# Authorized Field Change

**AFC G-03909**

**Subject:** Certain 7000 4X4 and 6X6 Models, Built Between August 4, 2003 and September 7, 2003, at the Garland Assembly Plant Do Not Have the Front Axle Engagement Sensor Installed on the Transfer Case

**Figure 1 Rear Cover Sensor Location and Wire Routing (Arrows) for 13TKA and 13TKC**

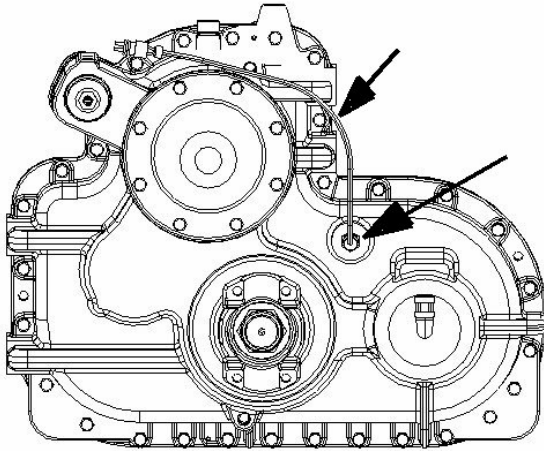
Certain 7000 Models, built between August 4, 2003 and September 7, 2003, at the Garland Assembly Plant do not have the front axle engagement sensor installed on the transfer case. Without the sensor, the indicator light will not turn on to indicate the vehicle is in all wheel drive.

1. Locate the front axle engagement sensor port (Figure 1 or Figure 2) and remove the pipe plug.
2. Apply Loctite 242 thread sealant to the engagement sensor threads, install and tighten to 200 to 258 Lbf-ft (270 to 350 Nm).
3. Locate the chassis harness connector. Connect the sensor to the chassis harness.
4. With the ignition switch in the ON position, shift the transfer case to all wheel drive and verify the indicator light is ON.
5. Secure wiring to keep it away from the transfer case output yoke.
